## HISTORIC PRESERVATION BOARD AGENDA

### Regular Meeting of the Historic Preservation Board

1. **235 S. First Street**: *Hattie DePuy House* – The applicant has applied for a Conditional Use Permit (CUP) to construct a 448 square foot addition to the existing 456 square foot home. The project also includes construction of a new 293 square foot detached garage for a total floor area of 1,197 square feet. The owner is also proposing to replace one of the windows in the front of the home with a window from the rear of the home that will be removed to accommodate the new addition.

BEING A RESOLUTION OF THE HISTORIC PRESERVATION BOARD OF THE CITY OF CAMPBELL RECOMMENDING THAT THE PLANNING COMMISSION APPROVE A CONDITIONAL USE PERMIT (PLN2016-258) TO ALLOW CONSTRUCTION OF AN ADDITION TO, AND REMODEL OF, AN EXISTING HISTORIC RESOURCE (HATTIE DEPUY HOUSE) LOCATED AT 235 S. 1<sup>ST</sup> STREET IN THE ALICE AVENUE HISTORIC DISTRICT.

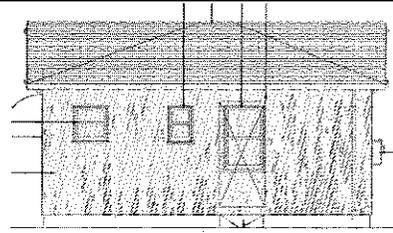
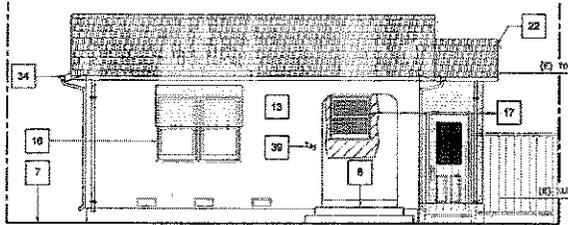
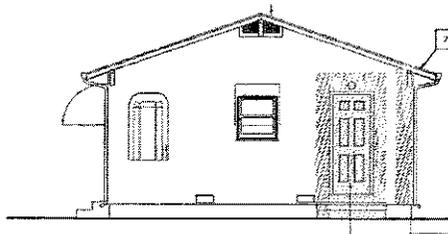
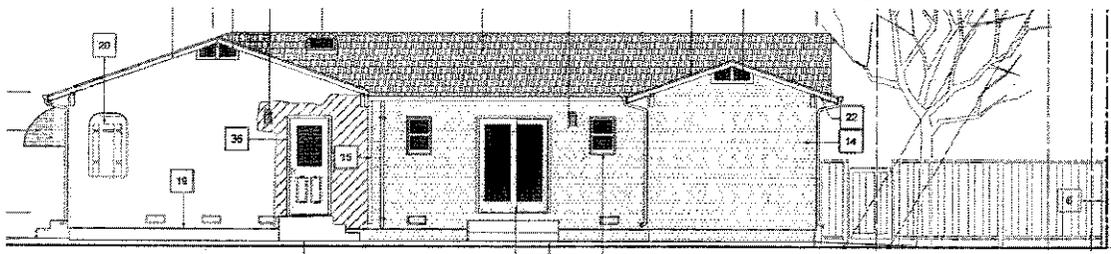
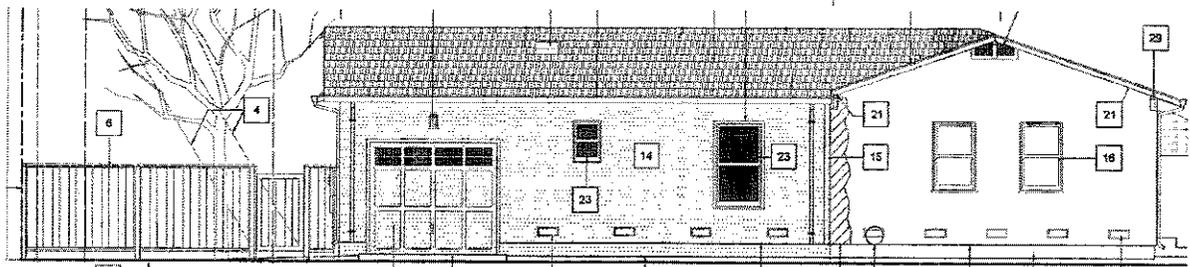
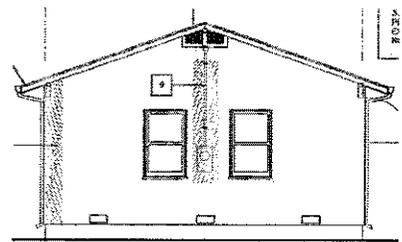
A review of the floor plan and elevations shows the lack of clear transition between original floor plan and the addition. As shown in the image to the right, an offset in the wall plane and/or plate height of the new addition would provide a more distinctive transition. Similarly, a different exterior material (e.g., wood siding) would distinguish the historic home from the new addition.

In response to staff's concerns, the applicant has stated that the goal was "to create an addition that complements the historic nature of the original home, not to create a visual mismatch to the original home." In this regard, the HPB should determine if the applicant has met the delicate balance of maintaining compatibility with the architectural style and character of the historic structure (e.g., materials, features, size, scale, proportion, and massing) while also clearly differentiating the non-historic features from the historic features of the home. If the HPB does not find the project to be consistent with the Secretary of the Interior's Standards for the treatment of historic properties, then the Board may recommend design changes as appropriate. The attached Resolution would need to be amended if any changes or conditions of approval are recommended (**Attachment 1**).
